Subject : Current Configurations of Pressure Suit and Parachute

The results of the meeting on January 16 thru 18 with regard to changes in the pressure suit and parachute are as follows:

FULL PRESSURE SUIT 1962
OXCART

THE PROBLEM:

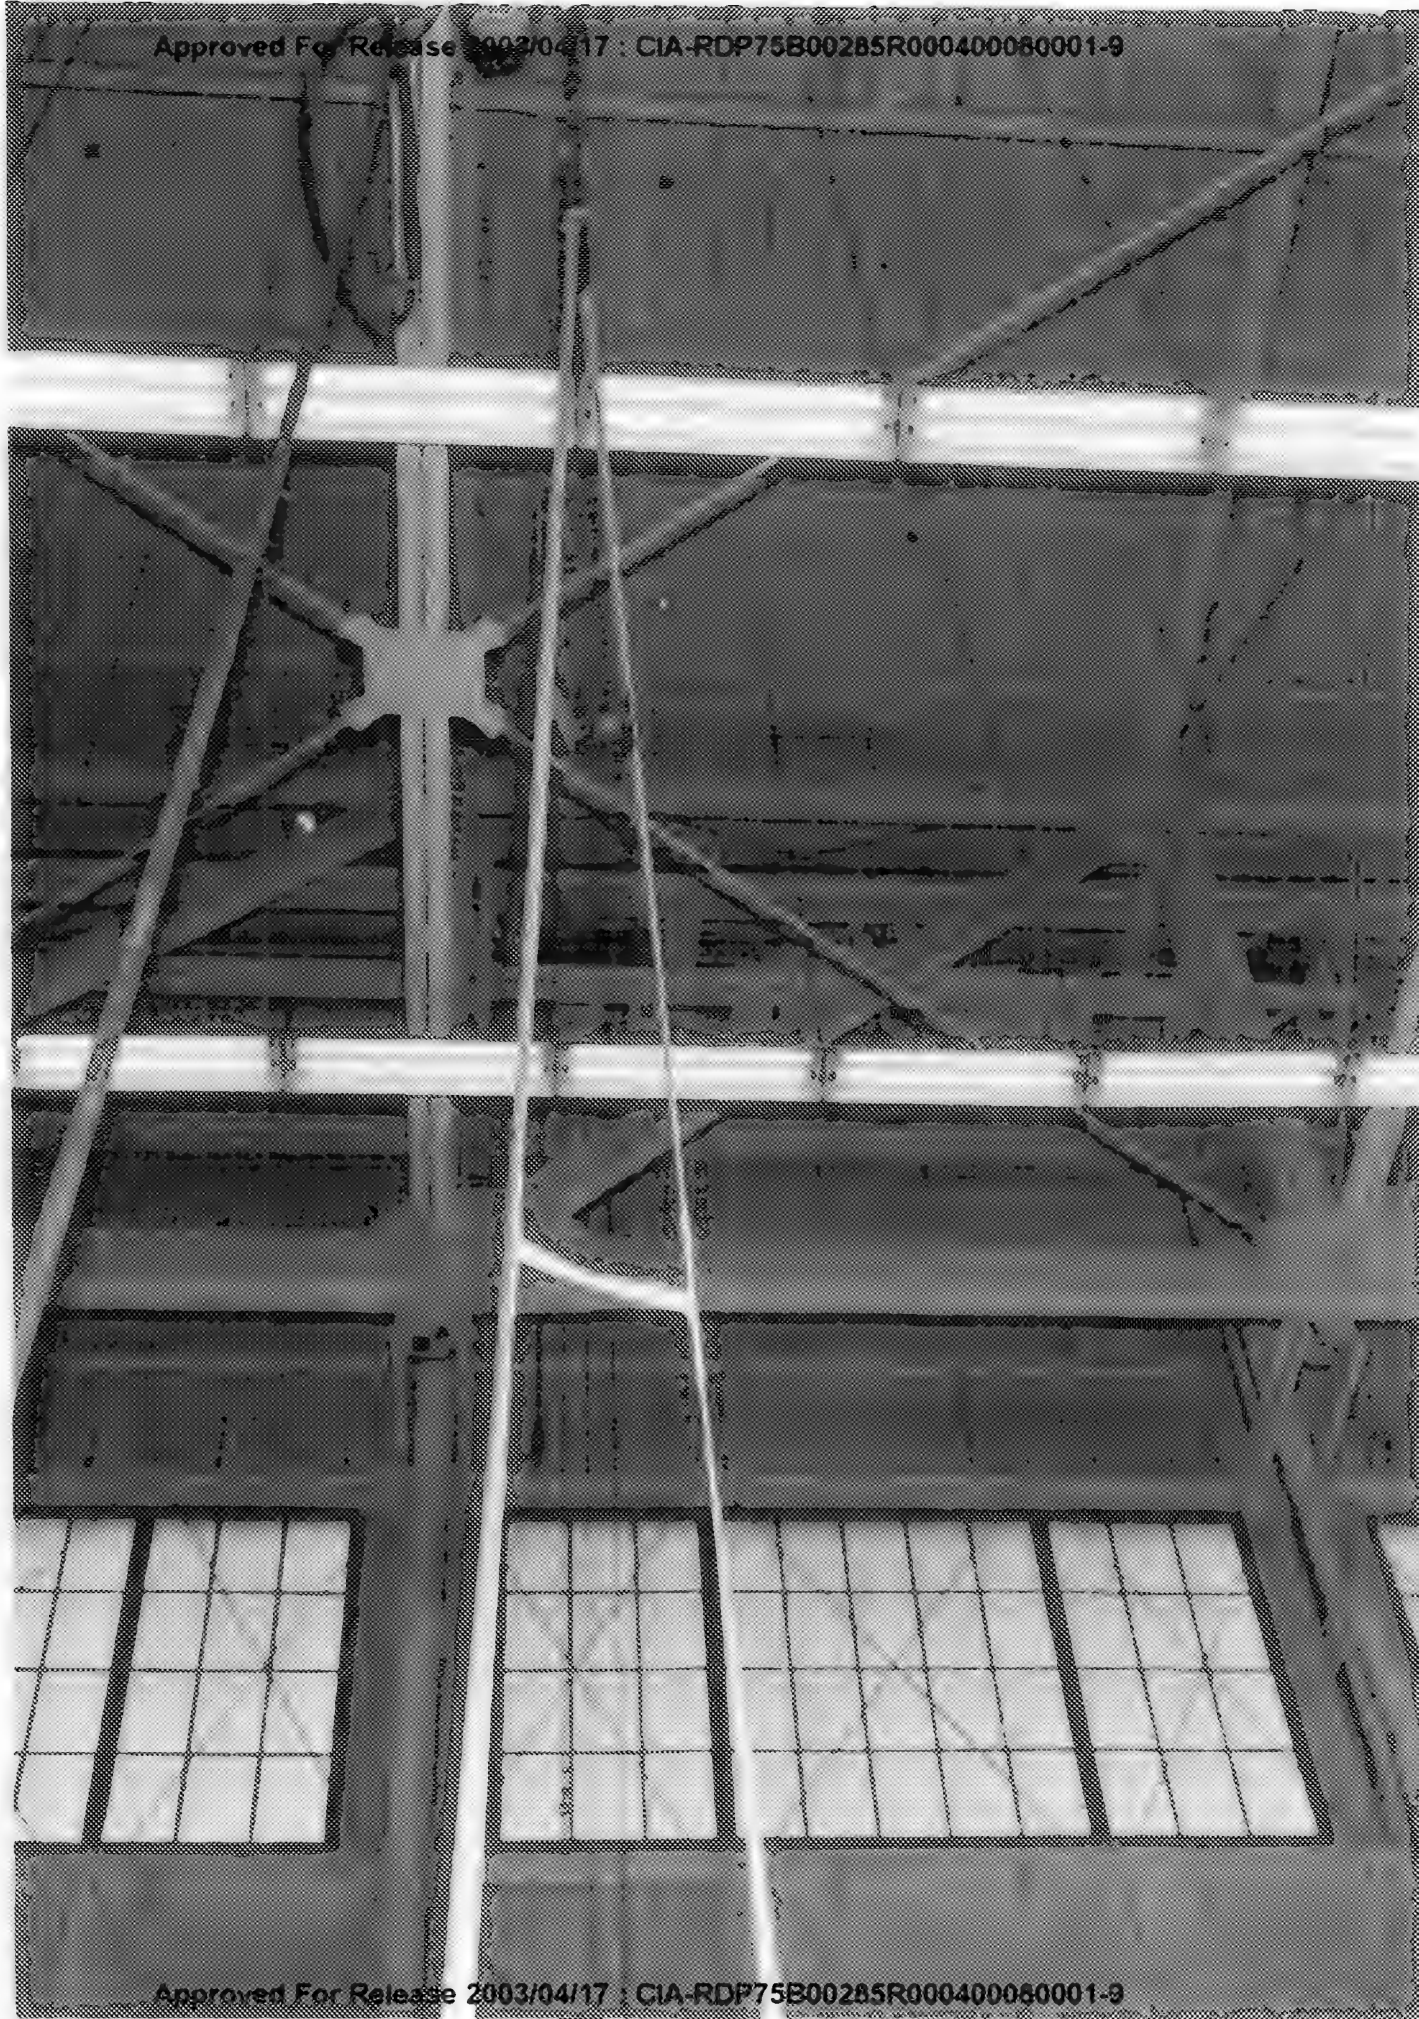
FIRST STAGE SUSPENSION

FITTINGS EXERT PRESSURE ON NECK
RING IMMOBILIZING THE HEAD
AND SUBJECTING NECK TO STRESS.

FIRST STAGE SUSPENSION FITTINGS:

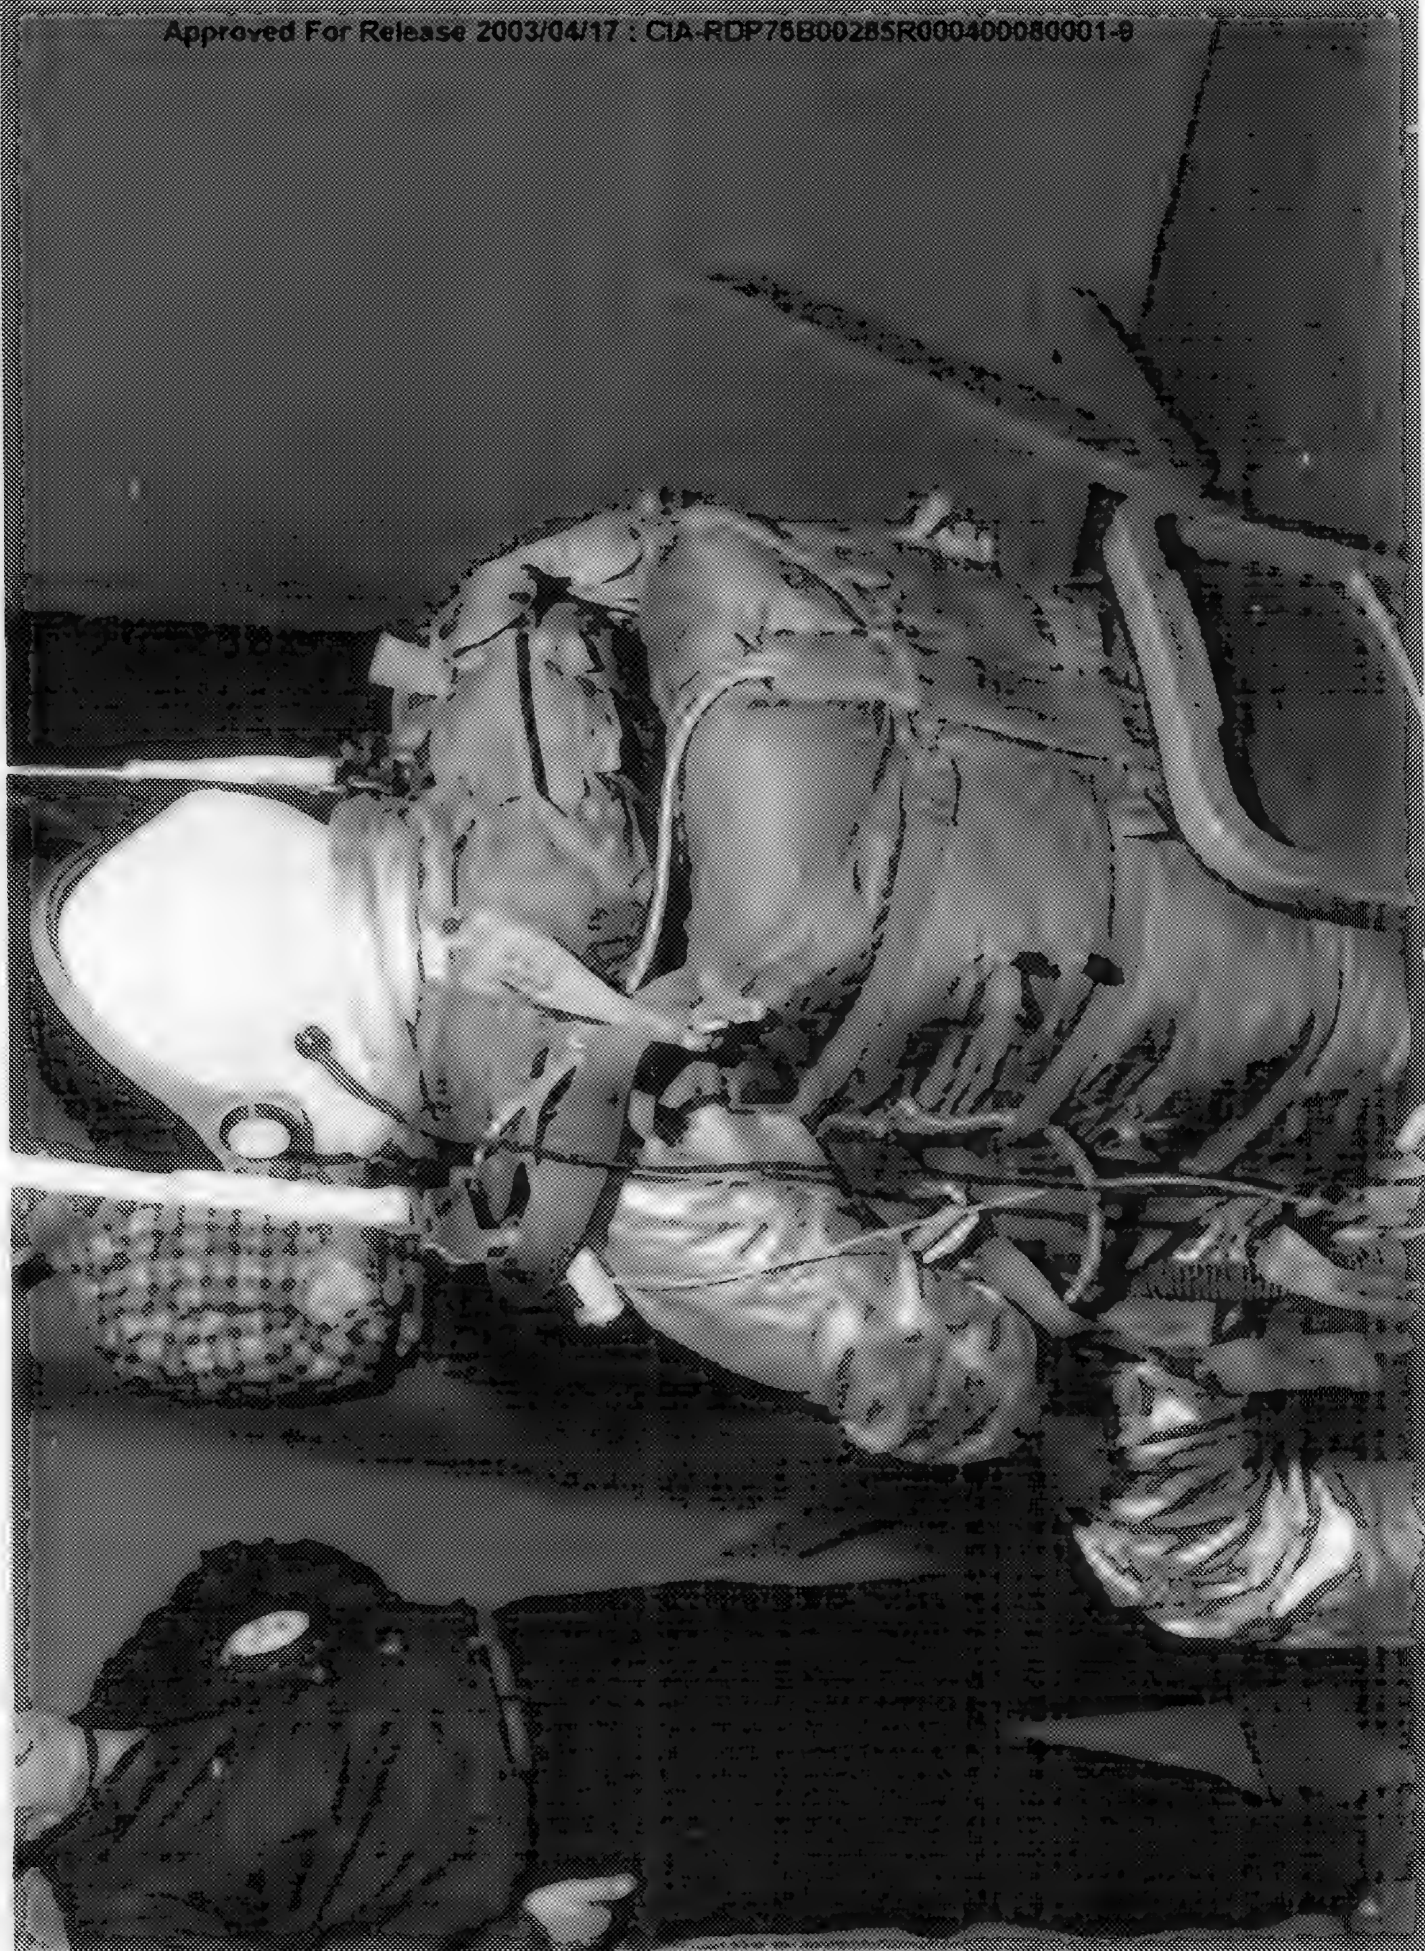
STOWAGE OF FITTINGS UNDERNEATH
NECK RING

a) NECK SPREADER COLLAR ADDED

b) FIRST STAGE FITTINGS MOVED AFT
1 1/2 INCHES AND OUTBOARD ON SEPARATE SUSPENSION
WEB

OBJECTIONABLE NECK PRESSURE
AND MOBILITY PROBLEMS IN SEAT

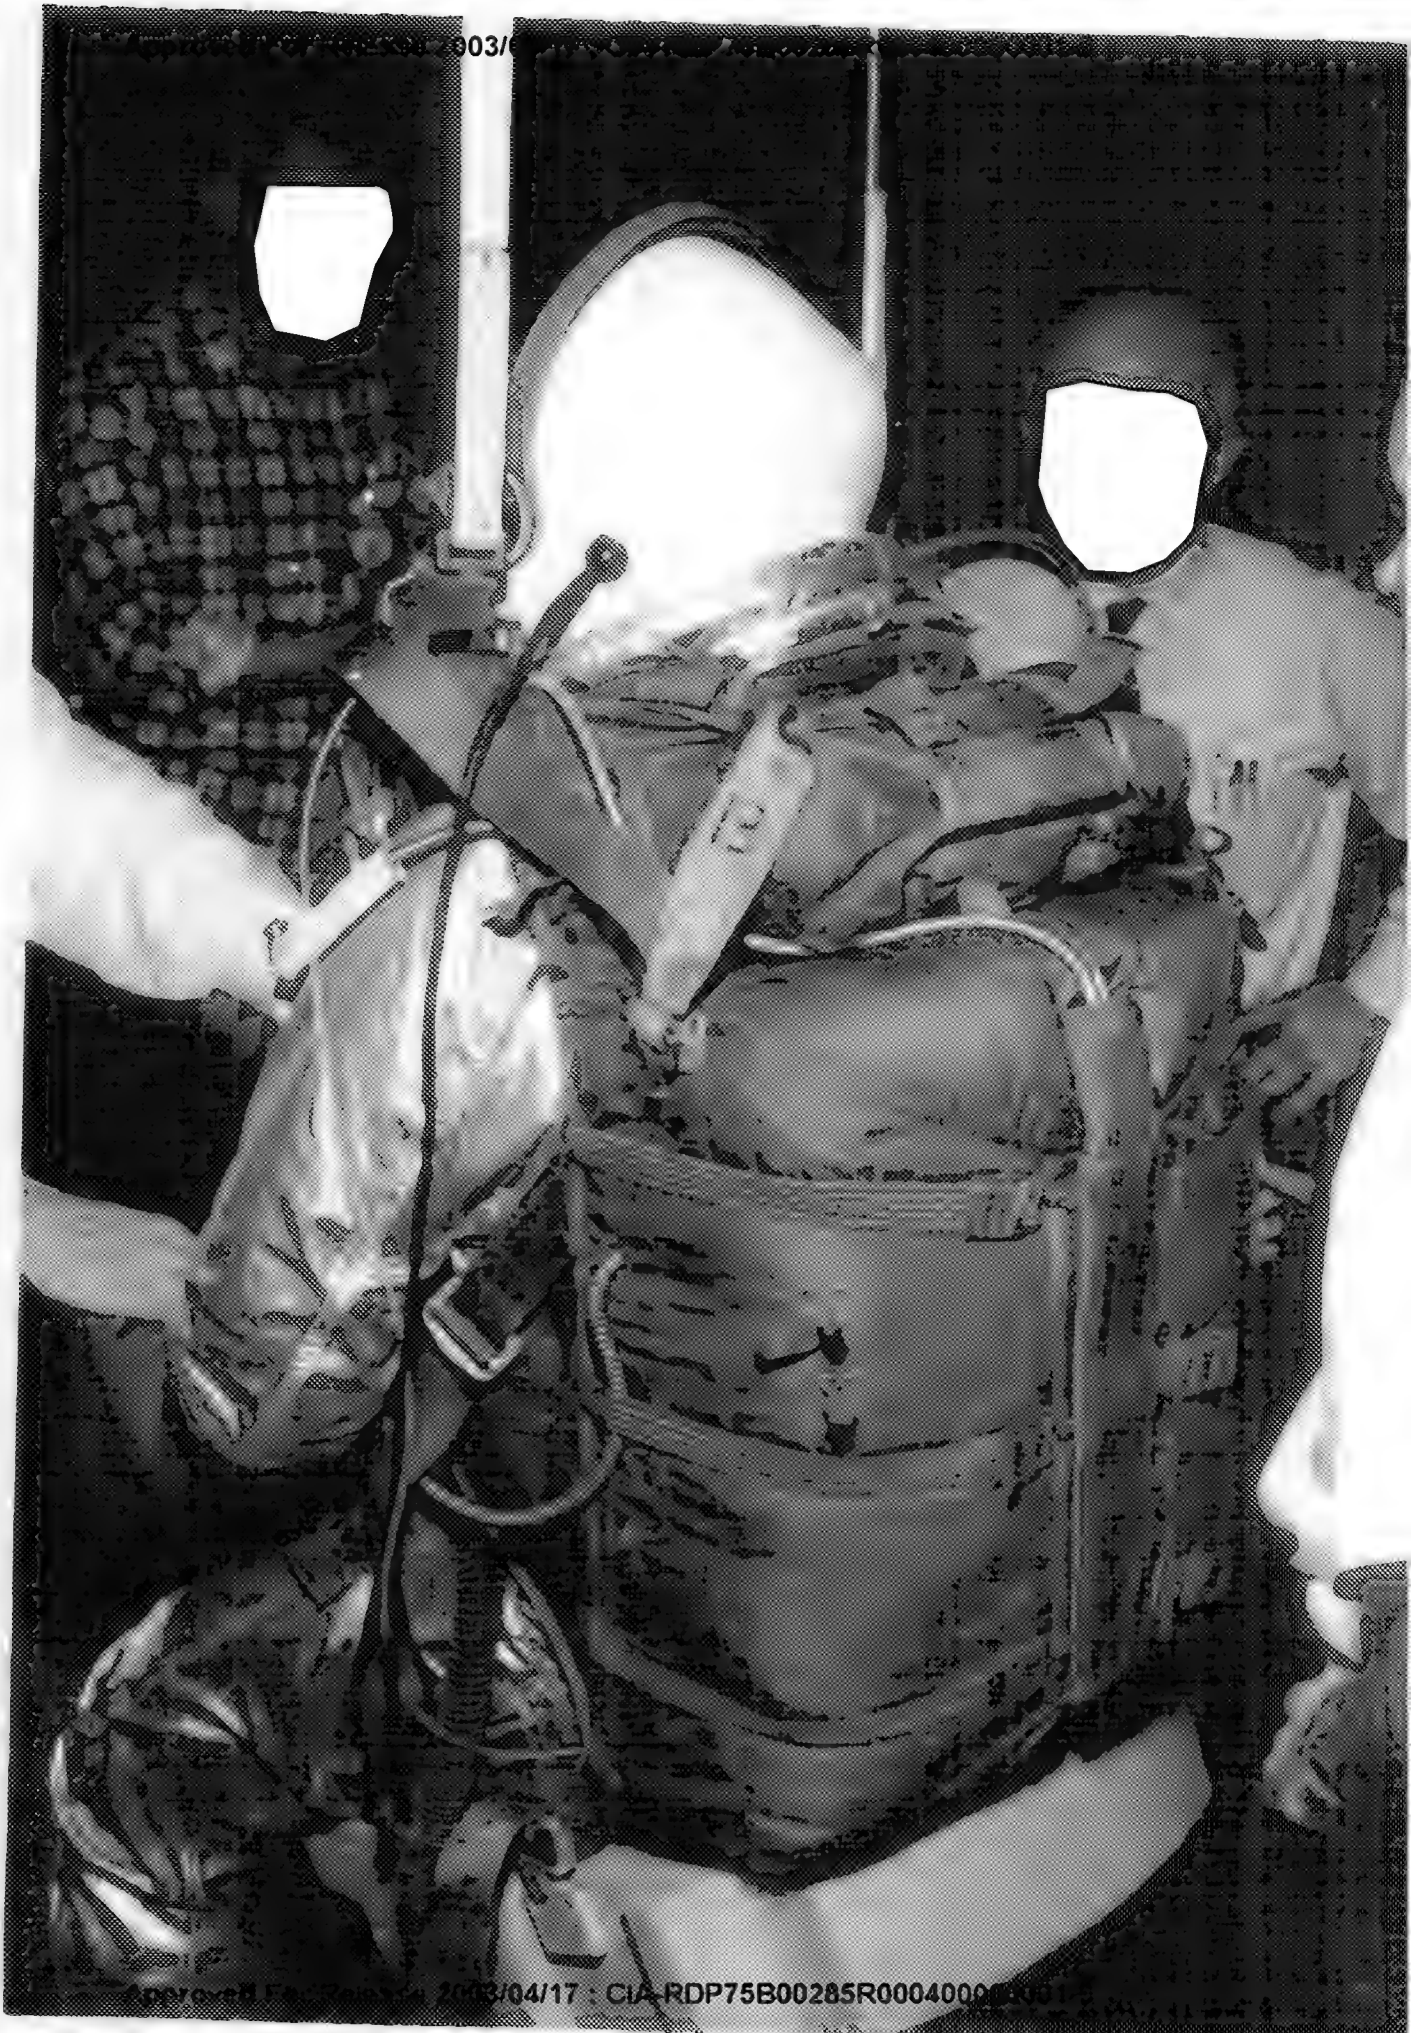
UNCOMFORTABLE NECK PRESSURE

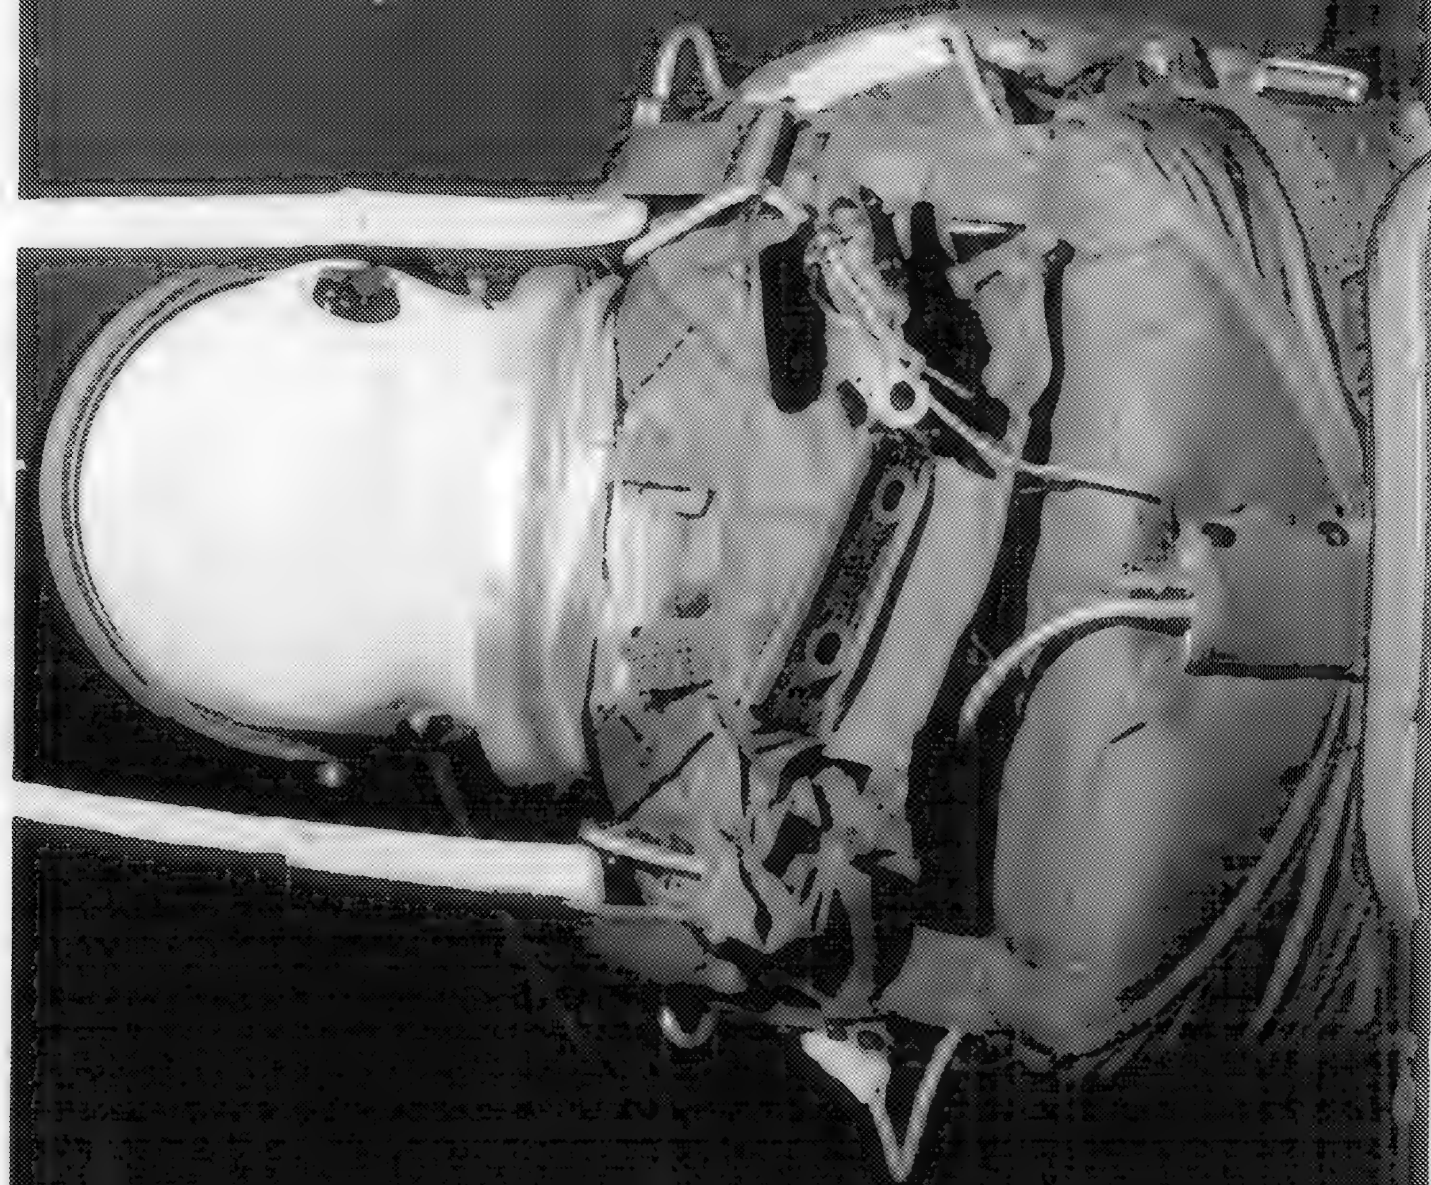
a) FIRST STAGE FITTINGS MOVED AFT $1\frac{1}{2}$ "
AND OUTBOARD ON SEPARATE SUSPENSION
WEBS.

a) IMPROVED MOBILITY IN SEAT OVER
NECK SPREADER COLLAR

4) FIRST STAGE SUSPENSION FITTINGS,
ALTHOUGH IMPROVED, STILL INTERFERE
WITH HELMET & NECK RING

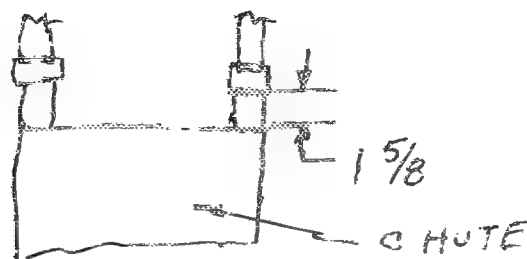
HELMET INTERFERENCE OBVIOUS

CONSIDERED ~~MOVING~~ ROTATING FIRST STAGE
FITTINGS 90° TO CLEAR NECK RING AND
HELMET
